STAFF REPORT 6-26-2019 MEETING

APPLICATION NUMBER 19-6256

ADDRESS: 2010 ATKINSON

HISTORIC DISTRICT: ATKINSON AVENUE.

2010 Atkinson Rear Door, applicant photo

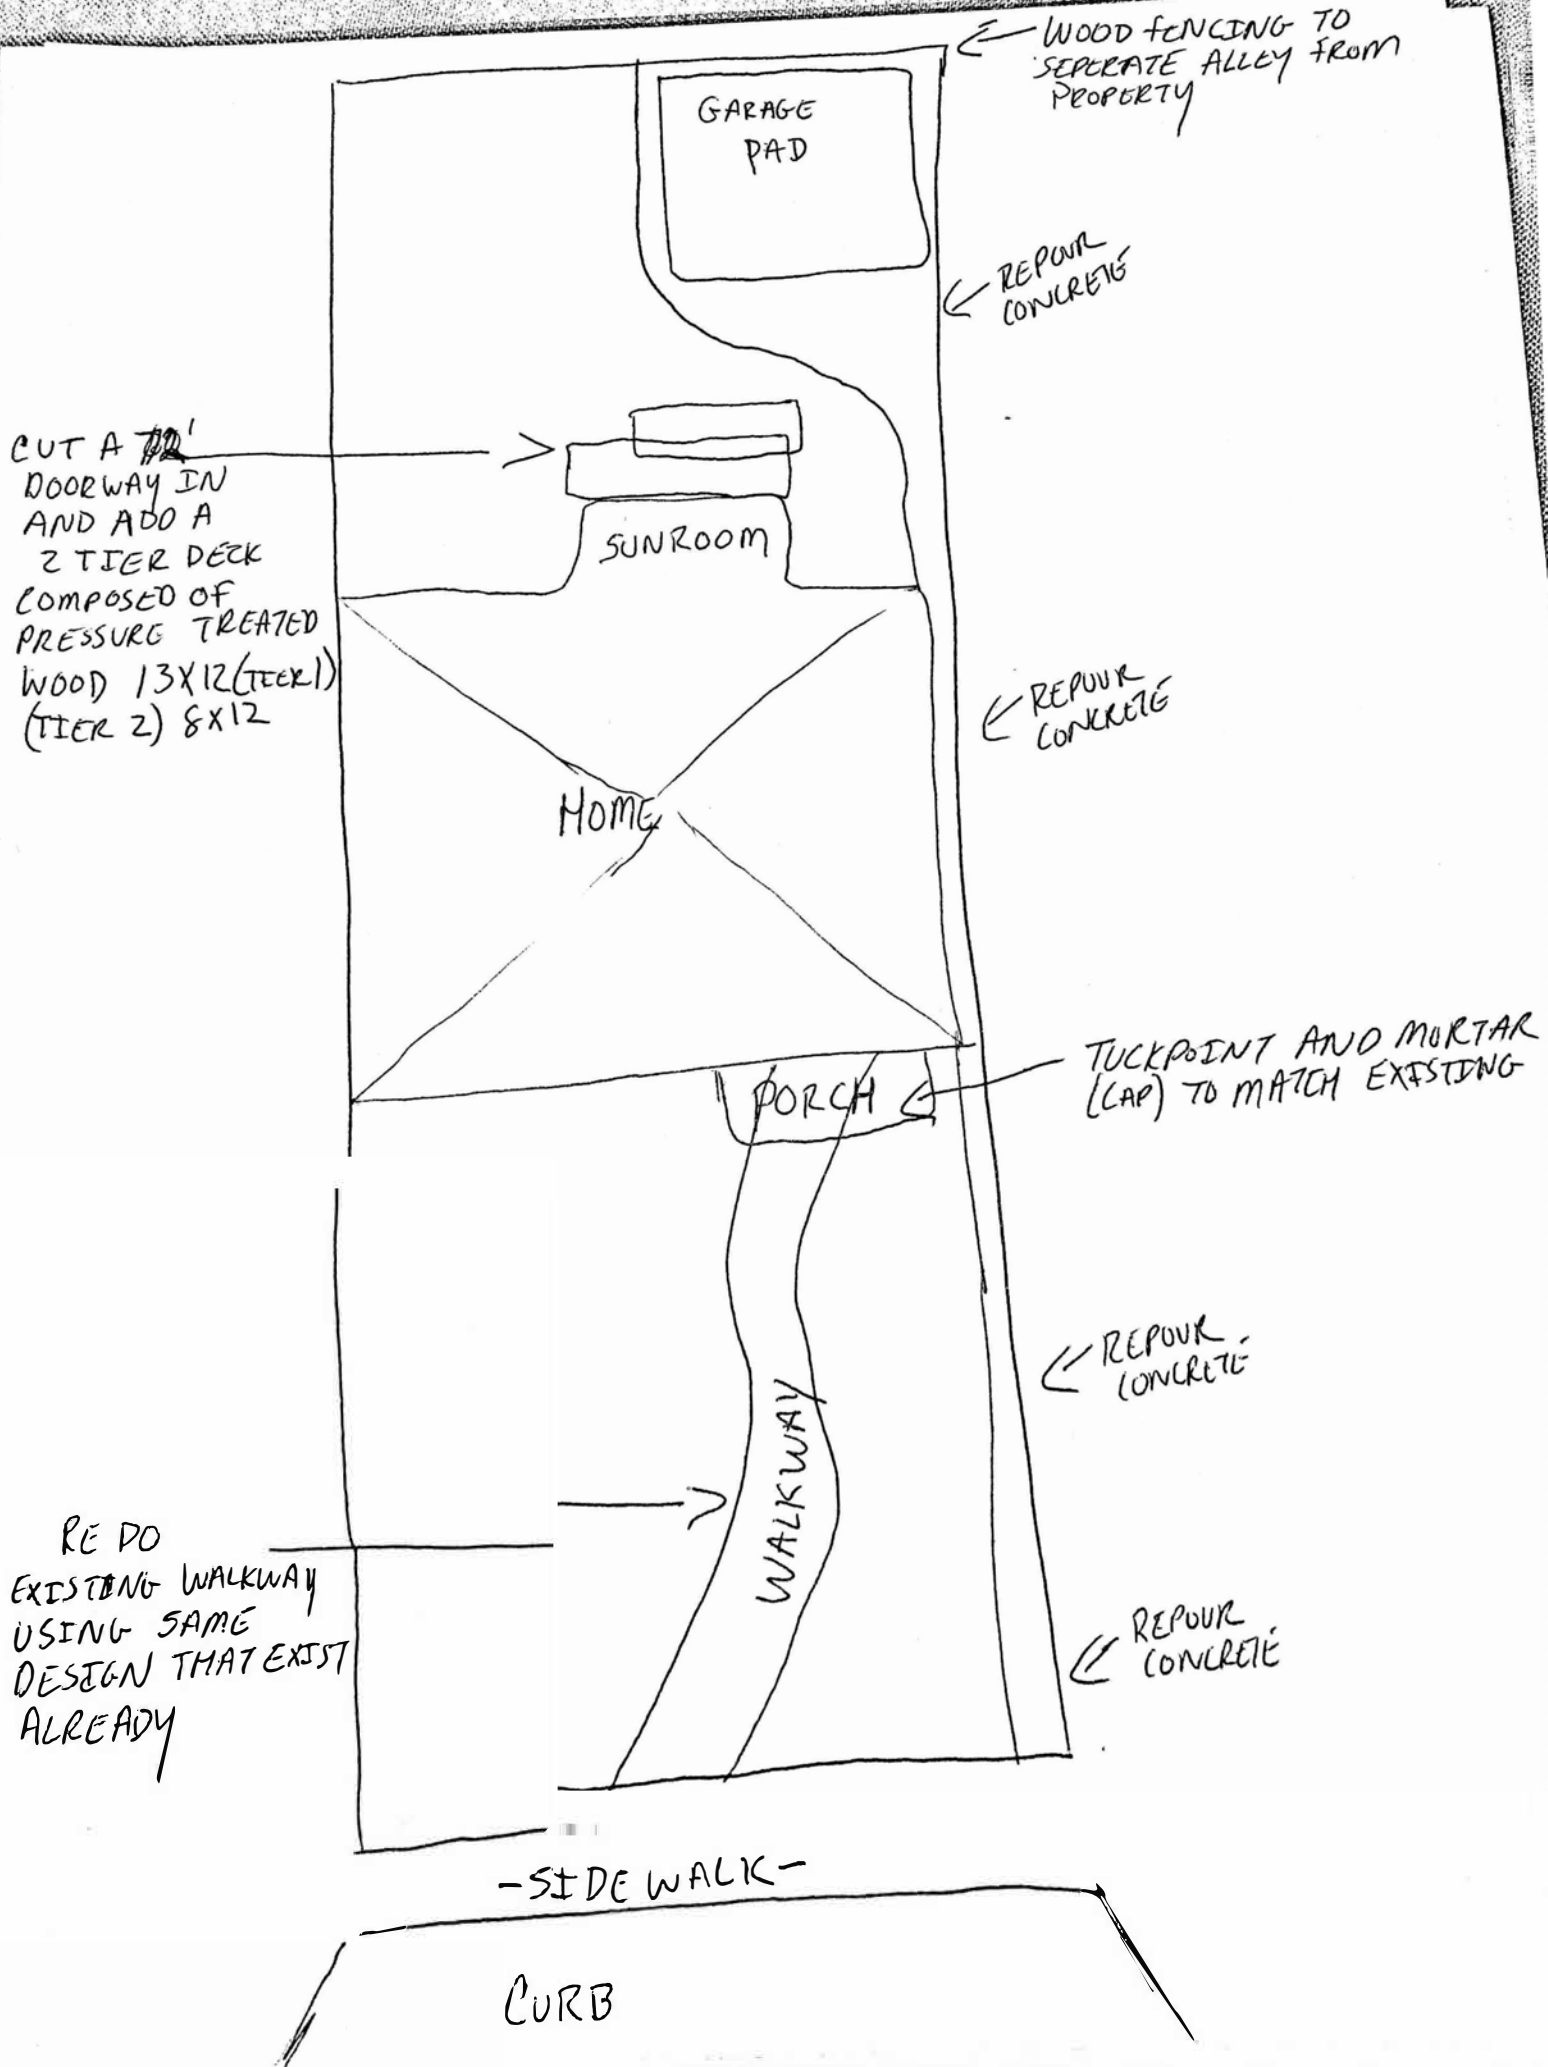
Rear elevation: The applicant proposes to fill in an existing door frame that appears to have been previously modified. Additionally, the applicant seeks to replace historic rear windows with new French Doors in the sun room. However, the applicant has not specified any replacement siding material. It is staff's opinion that the removal of historic windows to be replaced with the proposed door is not appropriate. Staff is unable to recommend in favor of the current rear elevation proposal.

It is staff's recommendation that the Commission do not issue a Certificate of Appropriateness for the proposed work based on the Secretary of the Interior's Standards for Rehabilitation Number 6) *Deteriorated historic features shall be repaired rather than replaced. Where the severity of deterioration requires replacement of a distinctive feature, the new feature shall match the old in design, color, texture, and other visual qualities and, where possible, materials. Replacement of missing features shall be substantiated by documentary, physical, or pictorial evidence* AND 9) *New additions, exterior alterations, or related new construction shall not destroy historic materials that characterize the property. The new work shall be differentiated from the old and shall be compatible with the massing, size, scale and architectural features to protect the historic integrity of the property and its environment.*

Pro Deck Design™

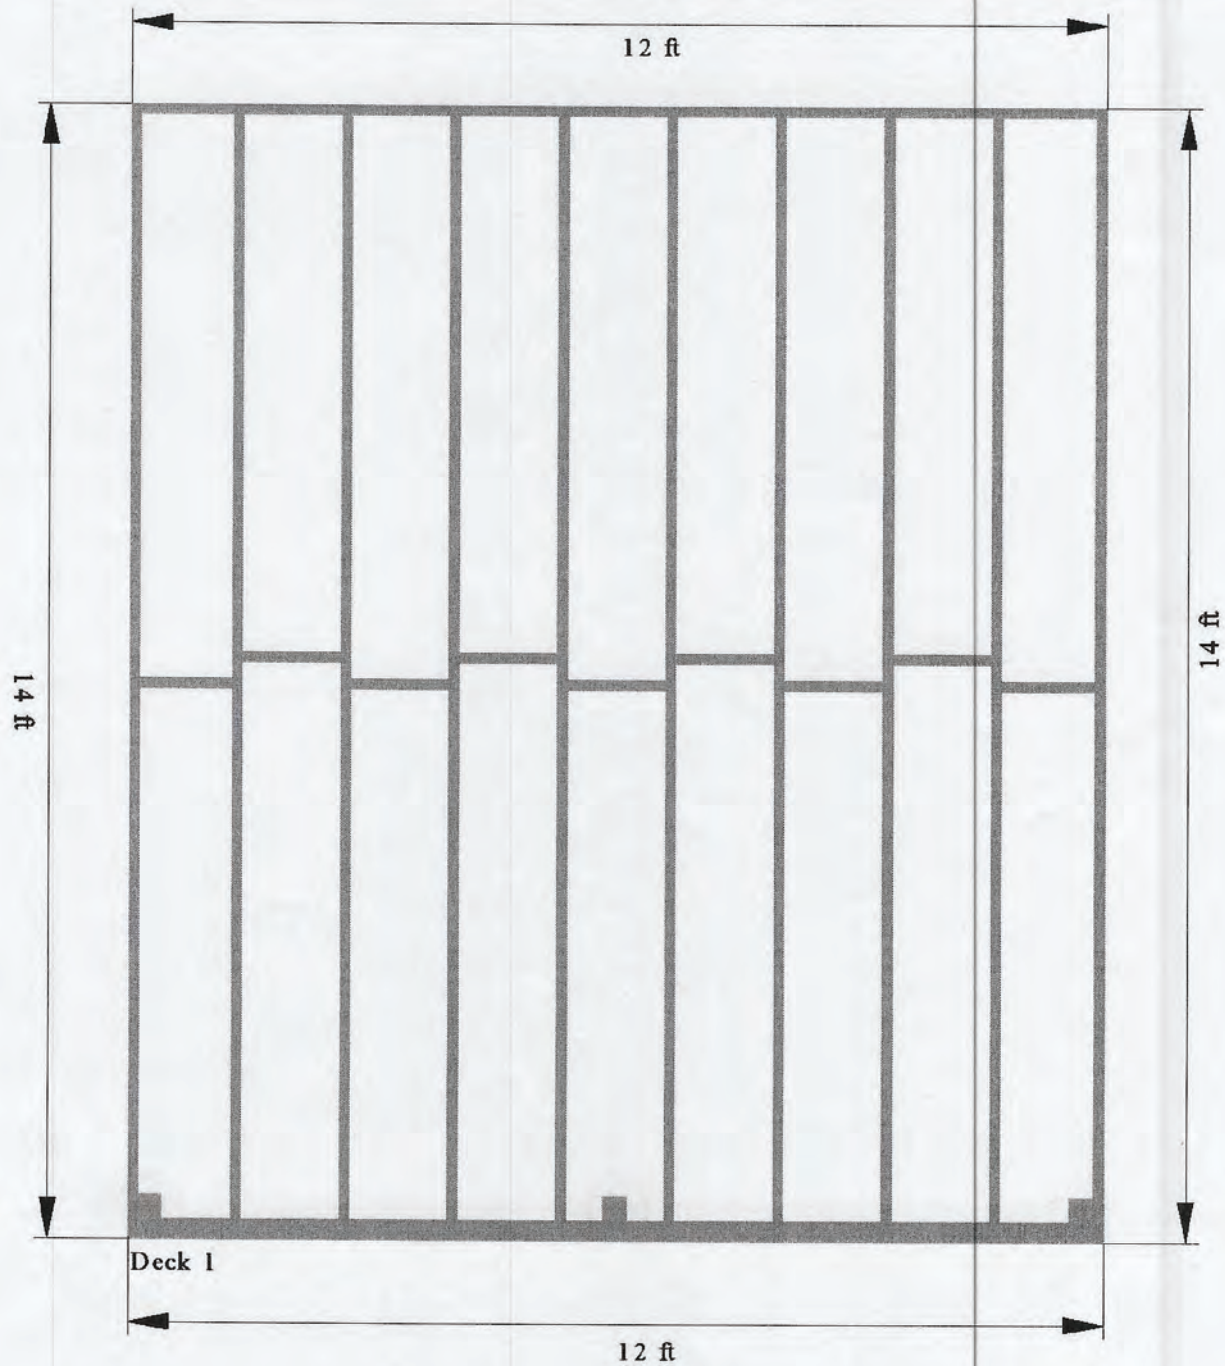
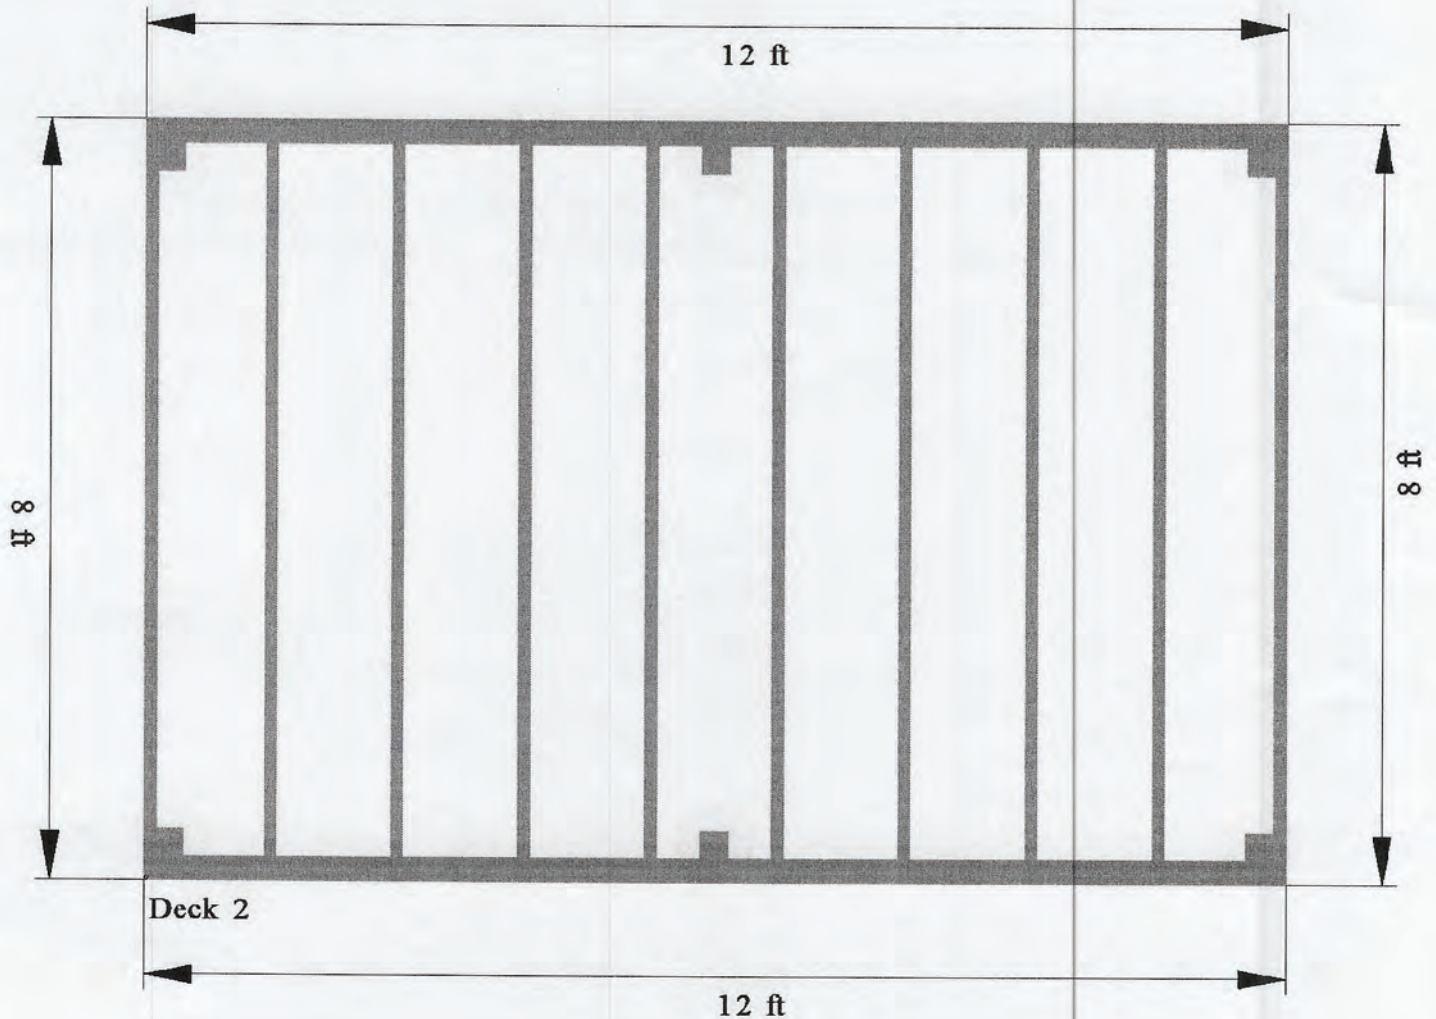
HDC staff finds the removal of the deteriorated concrete porch and the construction of a new treated wood deck to be appropriate. However, staff finds inconsistent dimensions proposed on the submitted site plan when compared to the deck design submitted after staff requested more detail. Staff recommends approval of the current deck proposal with the condition that the applicant provides more detailed information is specified about the size.

Staff conditionally recommends that the Commission do not issue a Certificate of Appropriateness for the proposed work based on the Secretary of the Interior's Standards for Rehabilitation Number 9) *New additions, exterior alterations, or related new construction shall not destroy historic materials that characterize the property. The new work shall be differentiated from the old and shall be compatible with the massing, size, scale and architectural features to protect the historic integrity of the property and its environment.* This approval is contingent upon the applicant providing more information to the satisfaction of the Commission regarding the construction of the porch and garage.

Pro Garage Design™

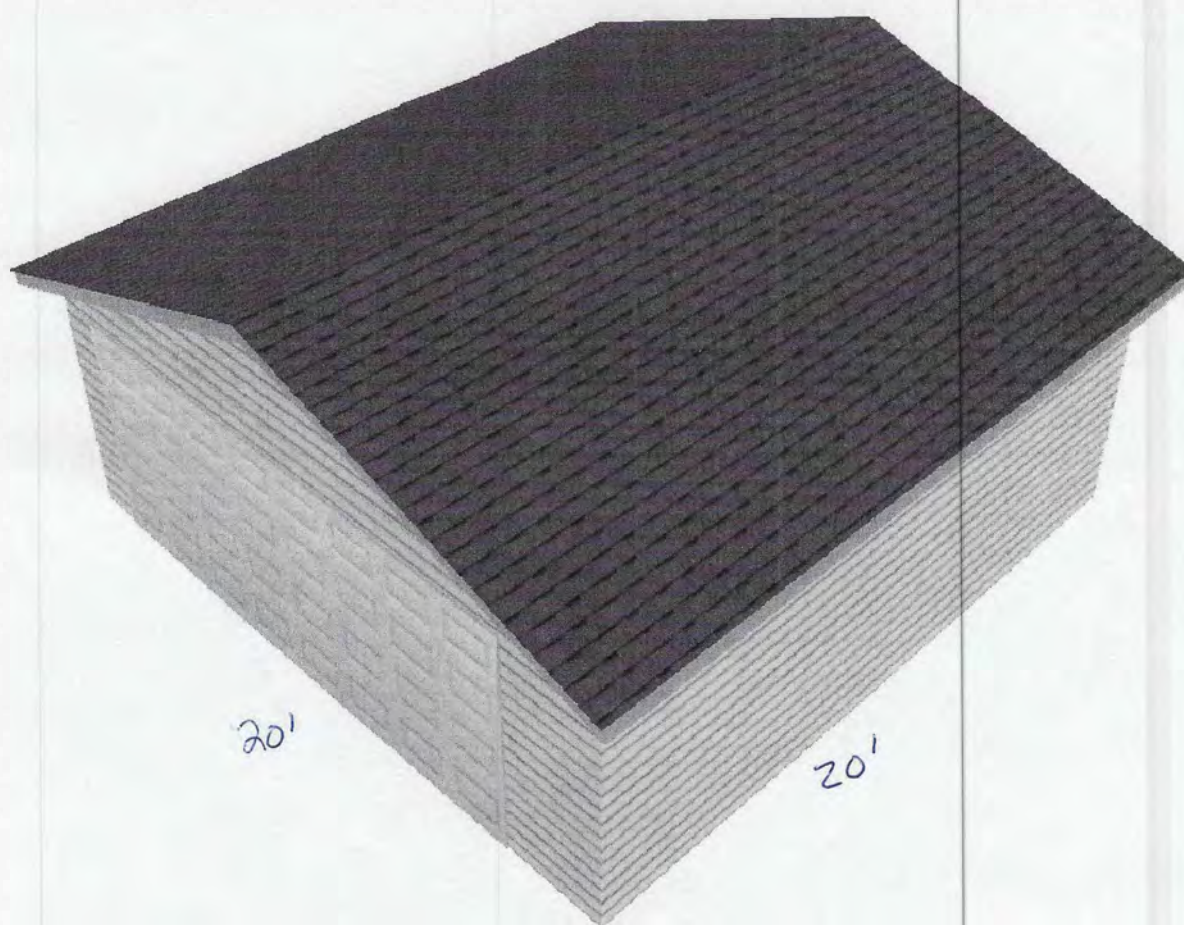
HDC staff finds the erection of a garage in the same footprint of the existing garage to be appropriate. However, no documentation has been provided about the previous garage, or when it was removed. The current proposal does not specify height, or siding beyond to match house, which is not specified. Staff recommends approval of the current garage proposal with the condition that the applicant provides more detailed information, including height, materials, roof and size. Additionally, staff would like to see specifications for all doors, roofing and siding materials.
